MOD2020/0589

PROPOSED ALTERATION AND
ADDITION TO THE EXISTING
DWELLING AS DETAILED

S4.55 (1A) modification

ISSUE	DATE	REVISION
PROJECT	62 Riviera Avenue Avalon	PROJECT # 190501
CLIENT	Mr D Chapman and Mrs H Chapman	DATE # 03/10/19
DWG	Elevations	SCALE @ A3 1:100
		DRAWN AW
		CHKD
		REVISION E

ISSUE	DATE	REVISION	PROJECT #
PROJECT			190501
CLIENT	DATE #	DWG #	
Mr D Chapman and Mrs H Chapman	03/10/19	A002	D
DWG	SCALE @ A3	1:100	
Site Plan	DRAWN	AW	
	CHKD		
	REVISION	D

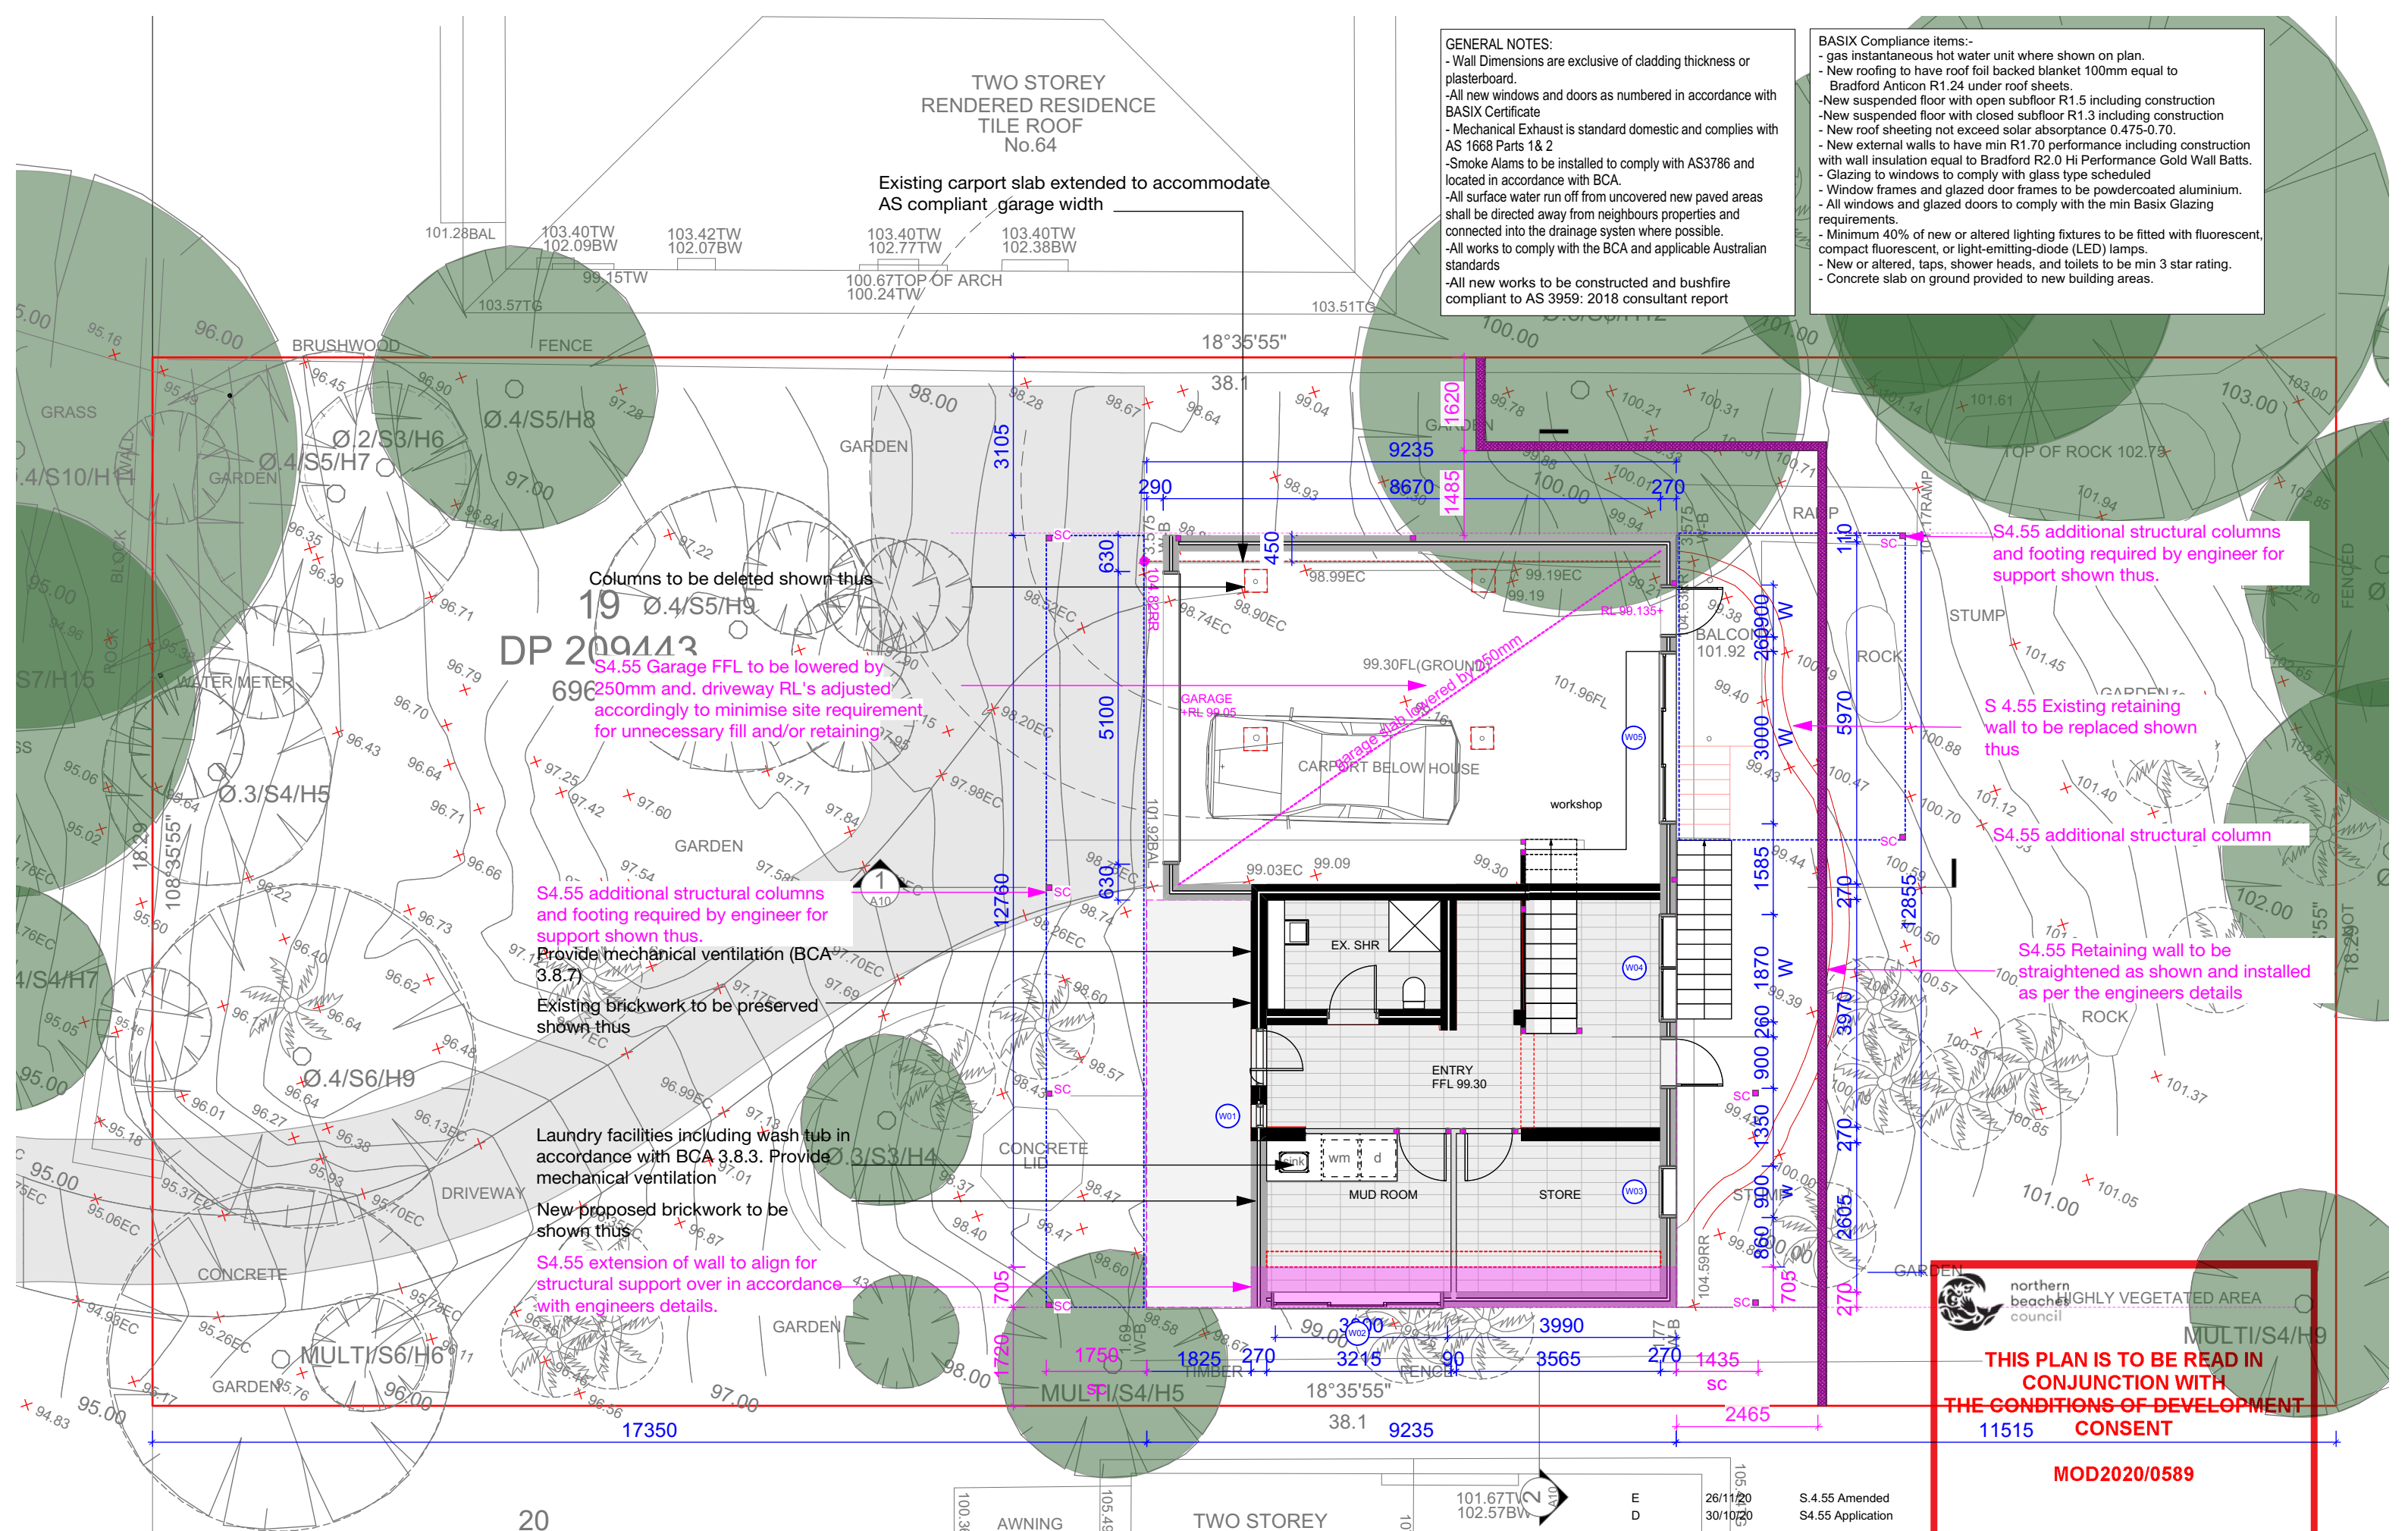
S4.55 Garage FFL to be lowered
by 250mm and driveway RL's
adjusted accordingly to minimise
site requirement for unnecessary
fill and/or retaining

S4.55 Existing retaining wall
to be replaced shown thus

S4.55 Retaining wall to be
straightened as shown and
installed as per the engineers
details

Existing carport slab extended to accommodate
AS compliant garage width

ISSUE	DATE	REVISION	PROJECT #
PROJECT			190501
CLIENT	DATE #	DWG #	
Mr D Chapman and Mrs H Chapman	03/10/19	A005	E
DWG	SCALE @ A3	1:100	
Lower Ground Floor Plan	DRAWN	AW	
	CHKD		
	REVISION	E

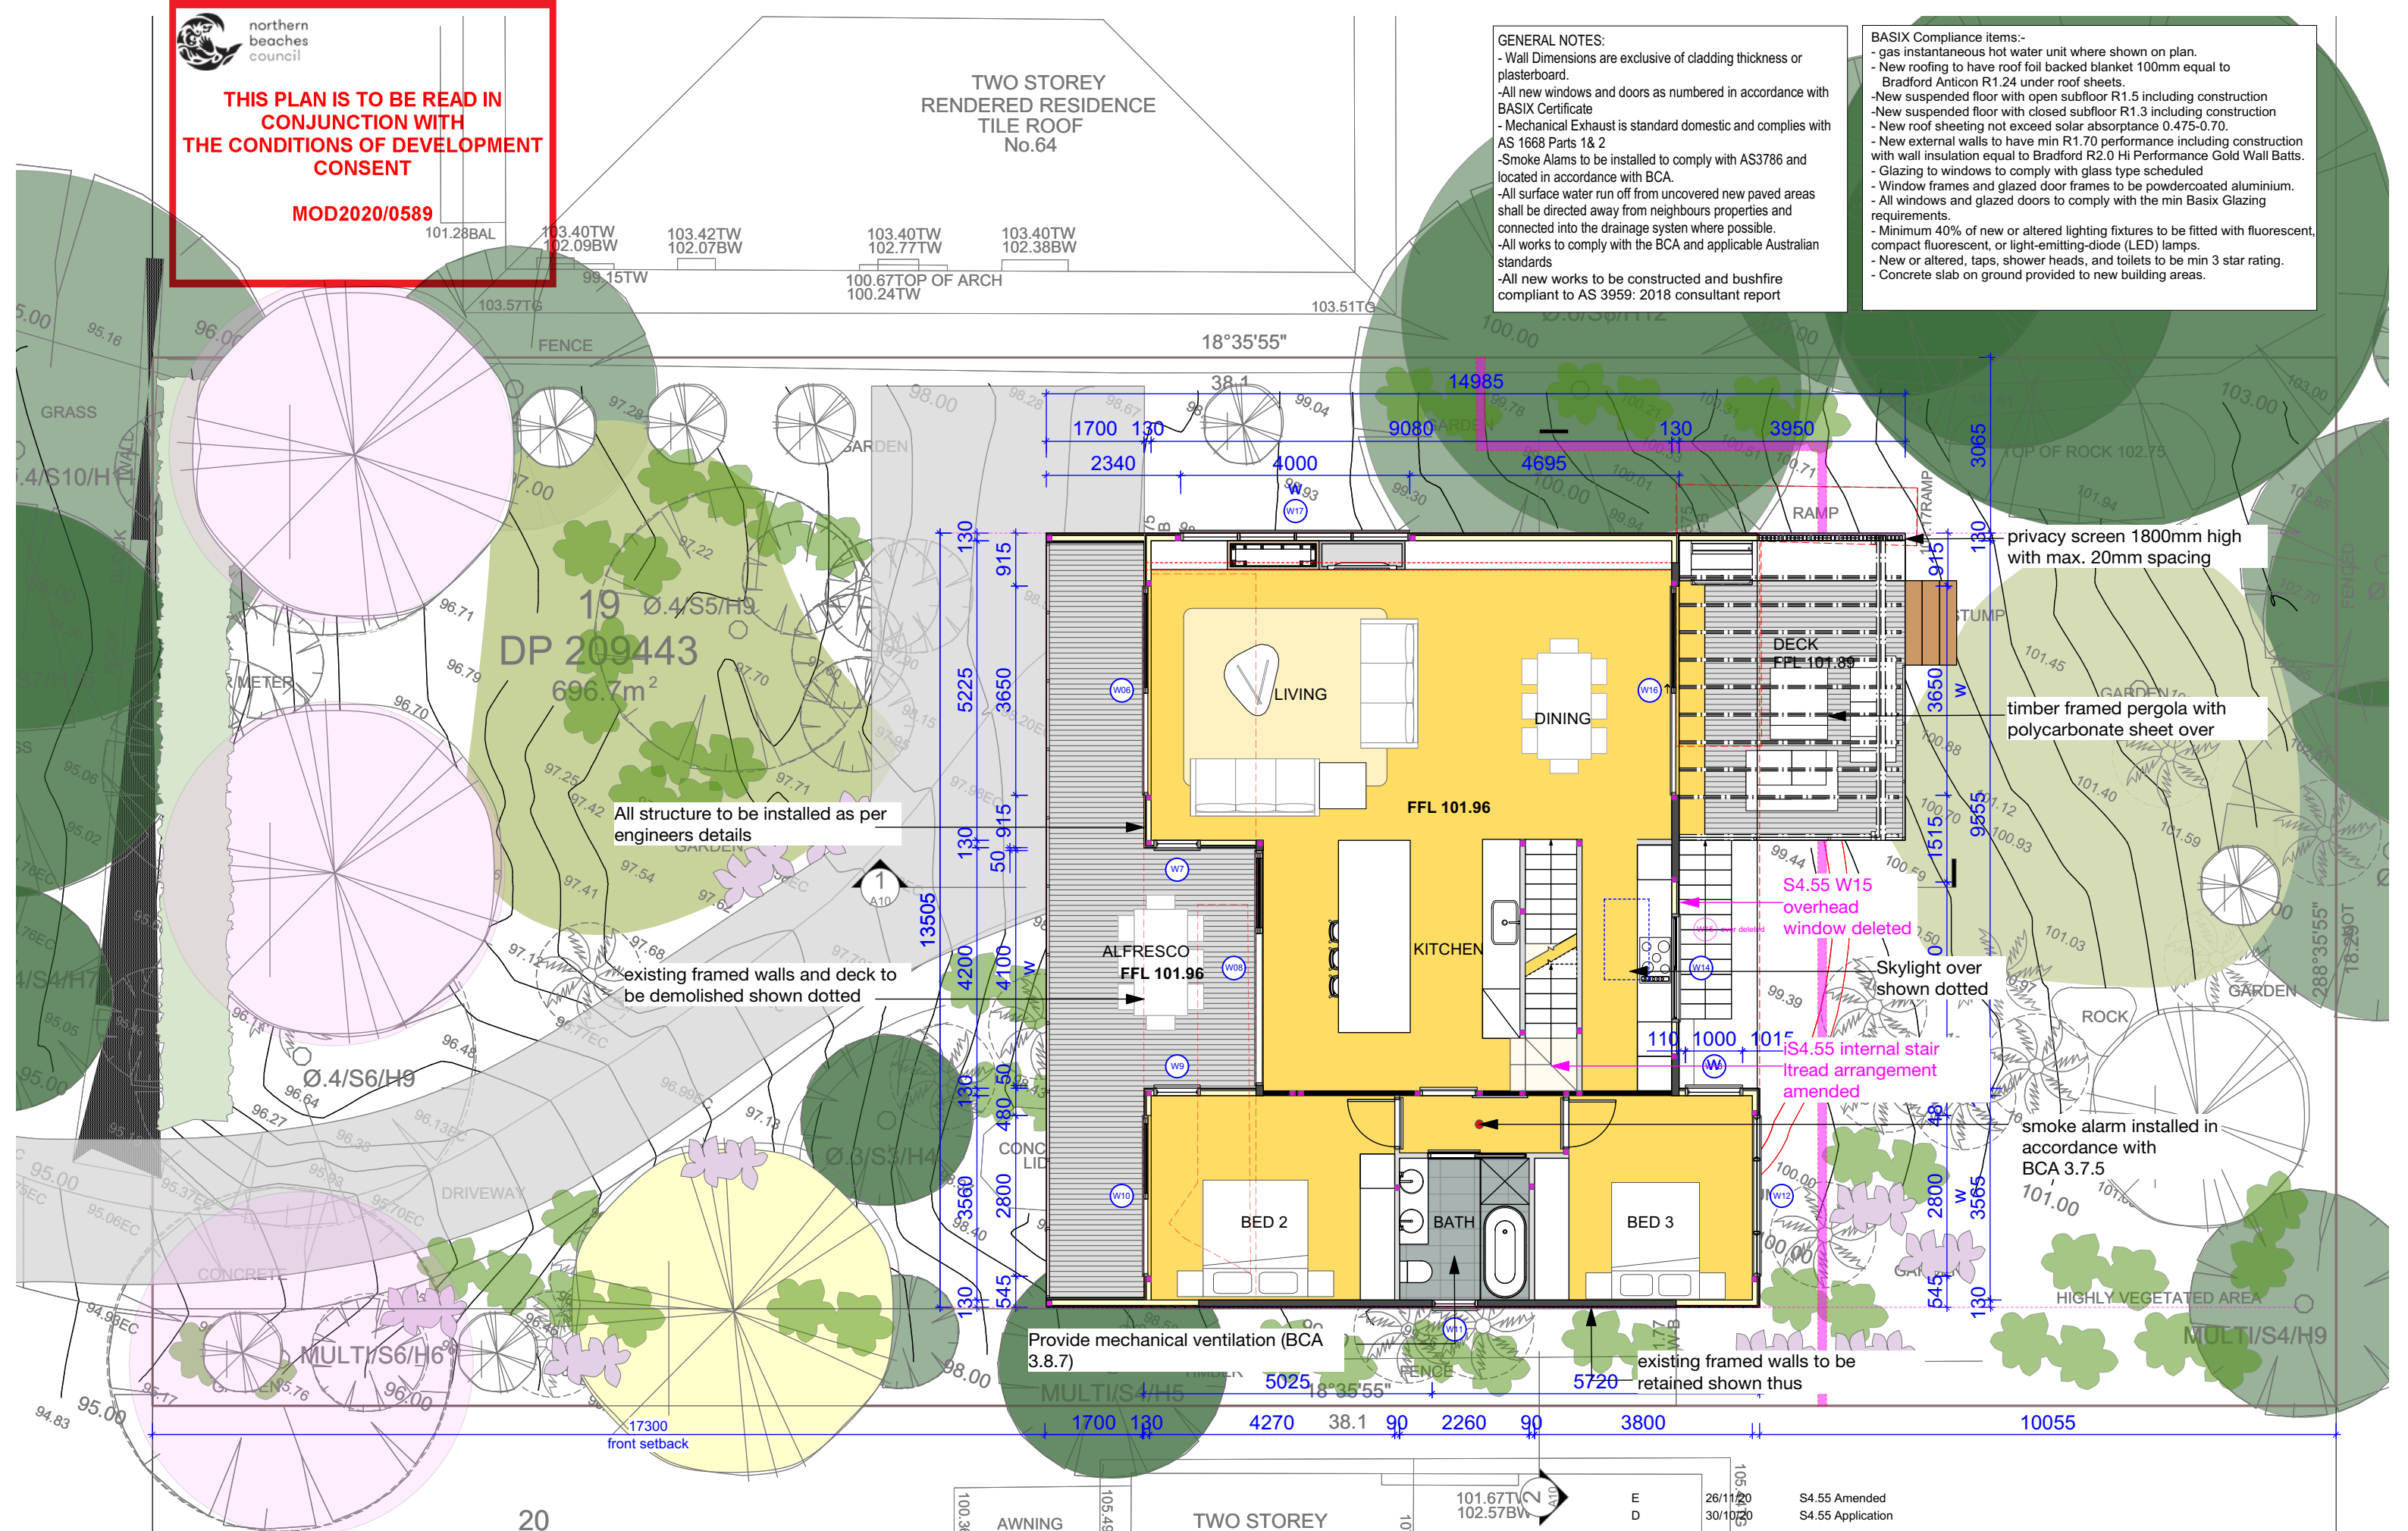
Columns to be deleted shown thus

S4.55 Garage FFL to be lowered by 250mm and driveway RL's adjusted accordingly to minimise site requirement for unnecessary fill and/or retaining

S4.55 additional structural columns and footing required by engineer for support shown thus.

S4.55 extension of wall to align for structural support over in accordance with engineers details.

S4.55 additional structural columns and footing required by engineer for support shown thus.

S 4.55 Existing retaining wall to be replaced shown thus

S4.55 additional structural column

S4.55 Retaining wall to be straightened as shown and installed as per the engineers details
